RB46-06/07

R301.2.2.2.2

Proposed Change as Submitted:

Proponent: Robert W. Rice, Josephine County Building Safety, Oregon, representing Josephine County Building Safety and Southern Oregon chapter of ICC

FIGURE R301.2.2.2.2(2)1

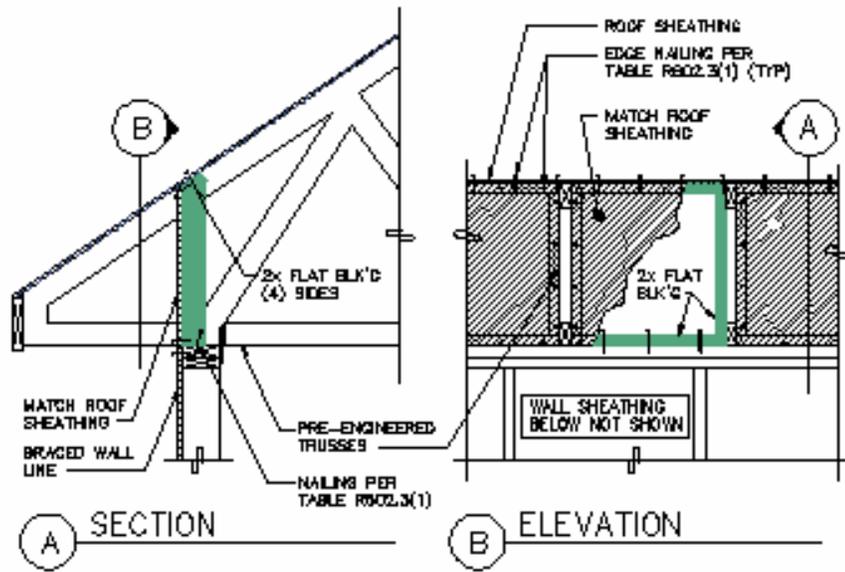
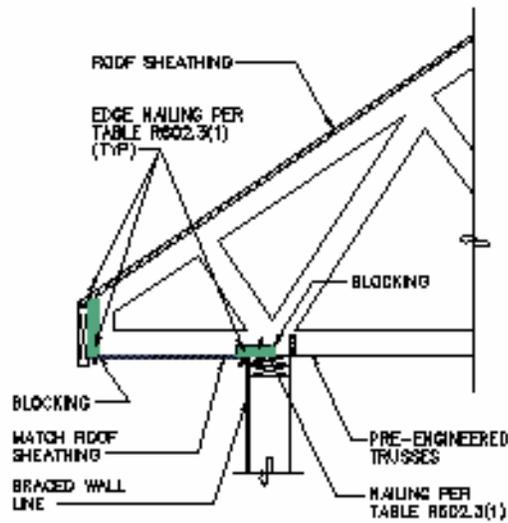
1. Portions of floors that do not support shear walls or braced wall panels above, or roofs, shall be permitted to extend no more than 6 feet (1829 mm) beyond a shear wall or braced wall line.
2. When the floor or roof diaphragm is positively connected to the braced wall line by one of the following methods:
 1. Engineered truss blocking for the extent of the wall line designed for 182 plf, or per *Wood Frame Construction Manual for One and Two Family Dwellings*, 2001 Edition, Table A-3.4, and attached to sheathing above and wall below per Table R602.3(1).
 2. Roof or floor diaphragm sheathing above is extended to the braced wall line, for the extent of the wall line, and attached to 2 x 4 minimum blocking with fasteners per Table R602.3(1). (See Figures R301.2.2.2.2(2)1 and R301.2.2.2.2(2)2.).
 3. Connected in a manner approved by the building official.

Delete Figures R301.2.2.2(2)1 and R301.2.2.2(2)2 and relocated to become Figures R602.10.8.3(1) and R602.10.8.3(2)

Figure R602.10.8.3(1) Alternate braced wall panel top plate connection.

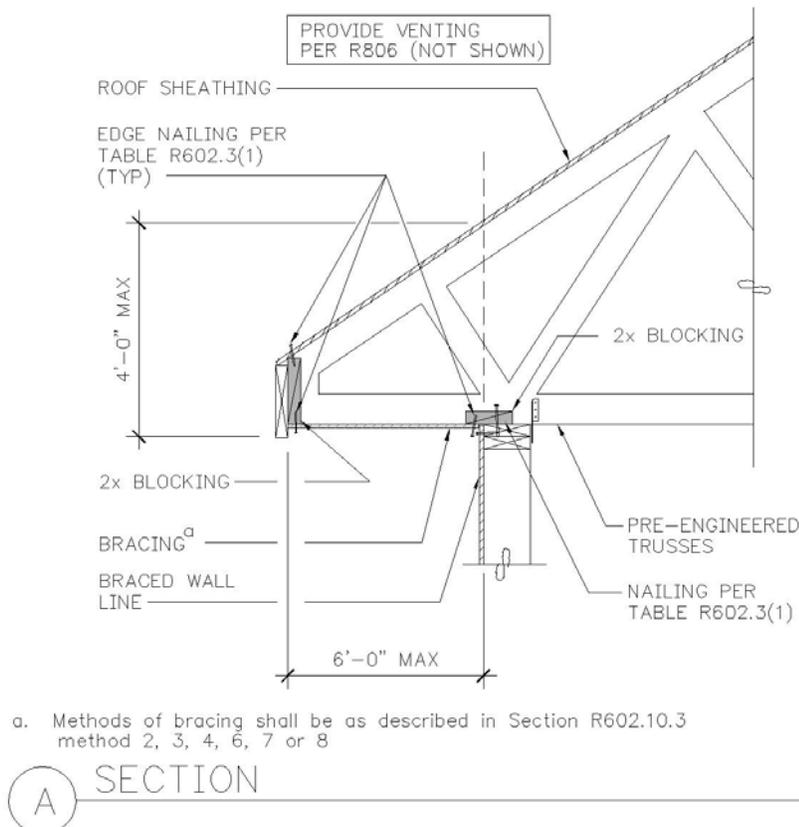
2. The code change as originally submitted did not define limits for the height of the prescriptive panels. This is now clearly stated in the revised details.

4. The committee expressed questions about venting through the sheathed panels that was not shown in the details. A similar detail is in the draft of the new, *ICC Standard for Residential Construction in High Wind Regions*. To be consistent, the same venting note has been incorporated into the details of this proposal.

5. To resolve concerns regarding the detail calling to "Match roof sheathing", the sheathing requirement is revised to allow other code-defined methods of bracing. The footnote "a" in the details is consistent with footnote "c" of Table R602.10.1.

1. In accordance with Figure R602.10.8.3(1)
2. In accordance with Figure R602.10.8.3(2)
3. With full height engineered blocking panels designed for values listed in American Forest and Paper Association (AF&PA) *Wood Frame Construction Manual for One- and Two-Family Dwellings (WFCM)*. Roof or floor sheathing above shall be attached to the blocking panels and the blocking panels shall be attached to top of wall in accordance with Table R602.3(1).
4. Designed in accordance with accepted engineering methods.

**FIGURE R307.1
MINIMUM FIXTURE CLEARANCES**

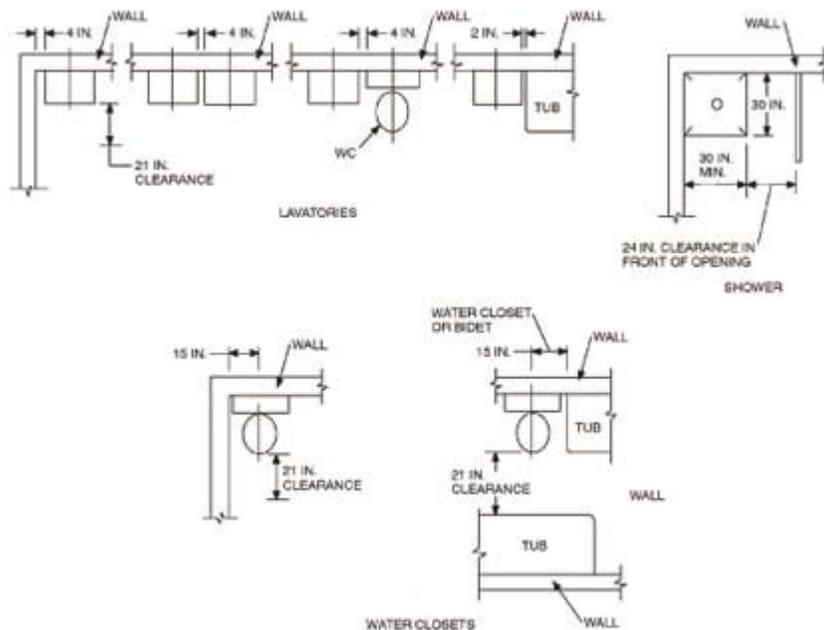
Reason: According to the *International Residential Code* commentary, the figures in R307.1 are necessary to make fixtures accessible and usable. Unfortunately, the side wall and fixture to fixture clearance requirements for lavatories greatly reduces the ability of homeowners and builders to use the wide variety of lavatory types and styles available in today's marketplace. If the purpose of Figure R307.1 is for disabled accessibility and usability, then clearance requirements should be based on those in ICC/ANSI A117.1.

The drawings in figure R307.1 do not indicate if these are wall mounted or free standing fixtures, or installed in the countertops of vanities, or kitchen cabinets, or all of the above. In addition; the drawings do not indicate if the clearance requirements are to edge of the fixture or to the edge of the bowl making this section of the code especially difficult to interpret and enforce.

Committee Reason: The proposed change to Figure R307.1 is not apparent. The change to the figure and substantiation should be brought back by the proponent through public comment for further consideration.

**FIGURE R307.1
MINIMUM FIXTURE CLEARANCES**

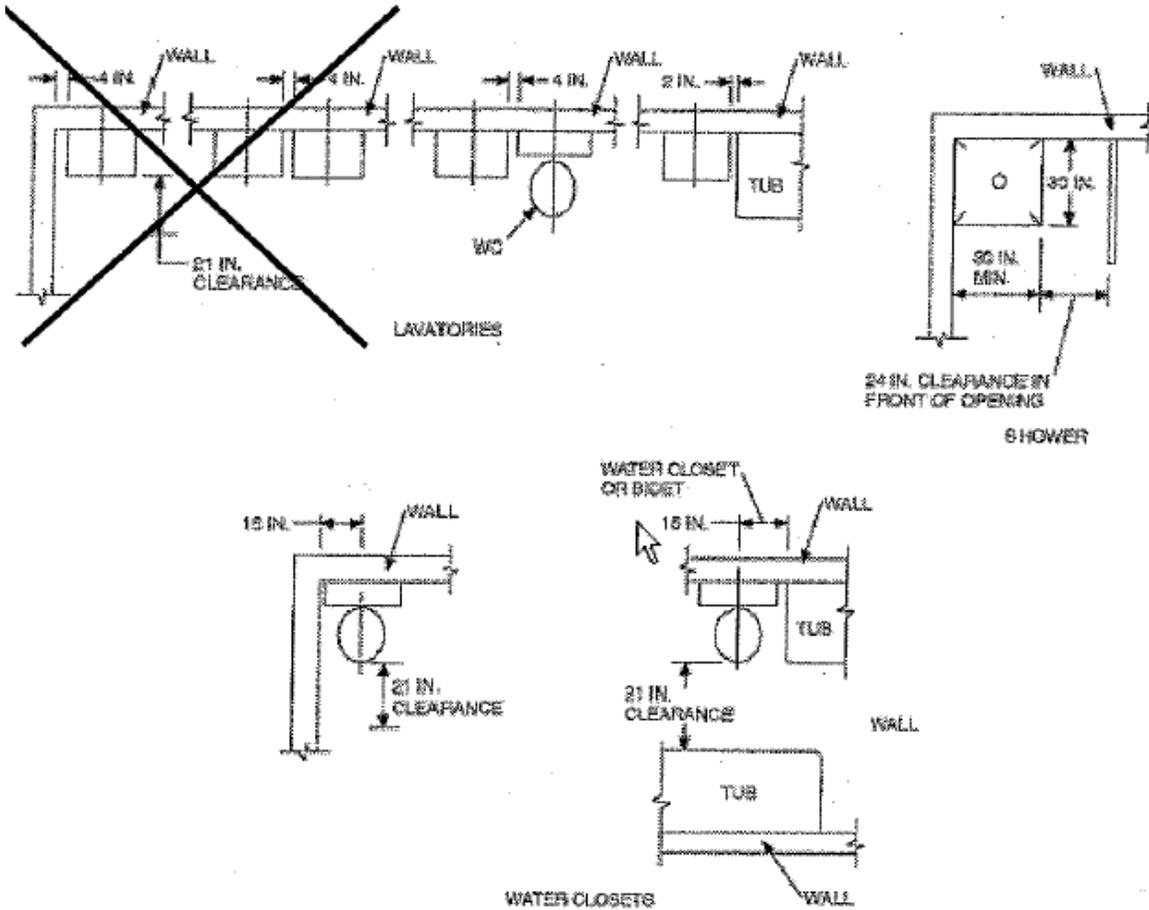
Committer's Reason: The cross-out indicated on revised Figure R307.1 was omitted in the monograph. As a result, the code change proposed was confusing to the committee and subsequently disapproved. This modification restores the original intent of the proposal.

Currently, the figure requires all lavatories to be placed 4" from side walls or provided with 4" separation between other lavatories. The code does not state if this requirement pertains to stand-alone lavatories, those placed within countertops and/or those formed integrally within the countertop. The code does not indicate if the dimension is taken from the bowl edge or from the fixture or counter that the bowl is installed within. This has led to considerable confusion in enforcement. Regardless, this requirement has absolutely no life-safety justification and has no place within a minimum standard code. We request approval as modified to eliminate this confusing and unnecessary requirement.

FIGURE 1 – CANTILEVERED BUILDING

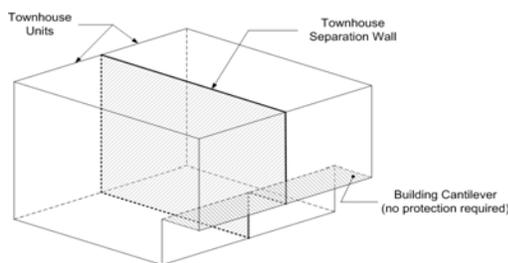
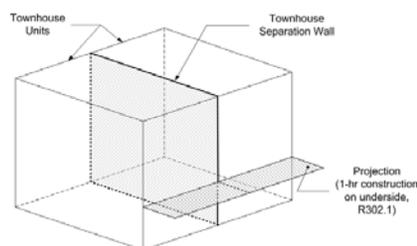
Cantilevers should be protected at least as much as projections. Projections such as balconies, located 4 feet or less from an adjoining townhouse must be protected by one-hour construction on the underside. (Section R302.1) Cantilevered overhangs are usually occupied floor area, often bedrooms, and need at least as much protection as balconies which typically are much less heavily occupied. Figure 2 shows a projection from a townhouse that must be protected with one-hour construction. The risk of fire spreading from the garage into the overhang presents a much greater hazard than the risk posed by the projection.

FIG. R317.2(1) – EXTENDED SEPARATION WALL

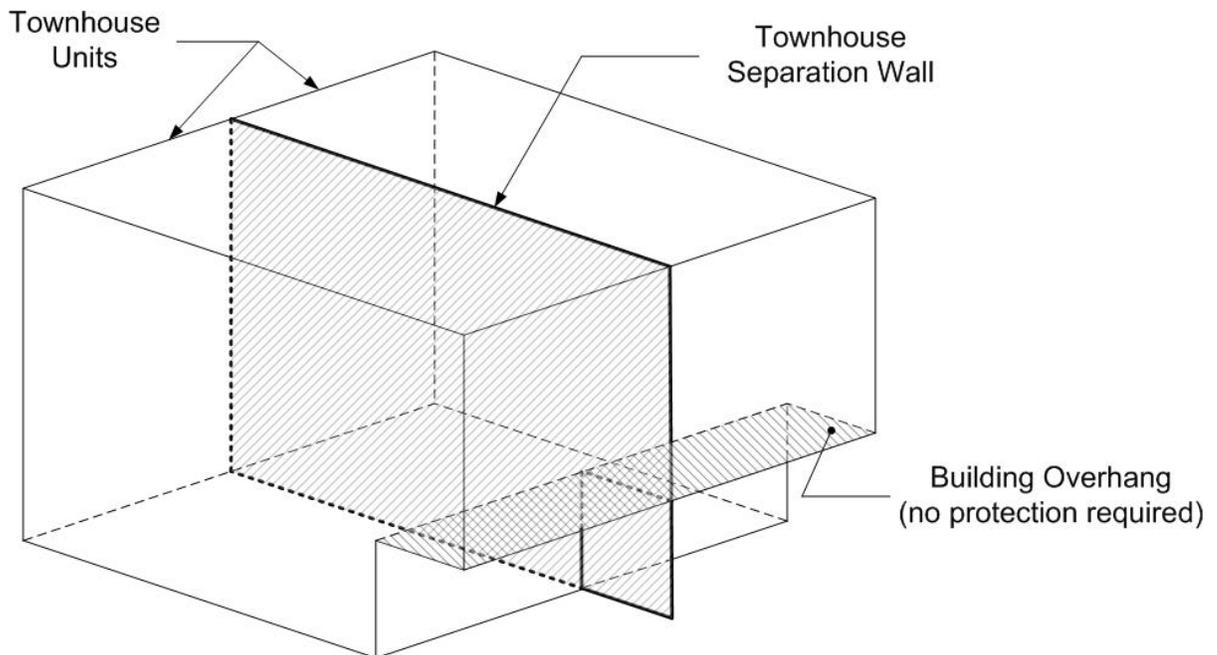
This proposal would give the designer two options how to create a complete separation between adjoining units. Choosing Item 1 would require the separation wall to extend outside the building envelope to the outer wall (see Figure R317.2(1)). Choosing Item 2 would not require the "wing wall", but would require 1-hour rated protection on the underside of the overhang, as is required for projections (see Figure R317.2(2)).

1. The fire-resistance-rated wall or assembly shall extend to the outside face of the upper story, creating a continuous separation from grade to the roof for the full length of the separation wall (see Figure R317.2(1)); or
2. The exposed underside of the overhanging floor-ceiling assembly shall be protected as required for projections in Section R302 (see Figure R317.2(2)).
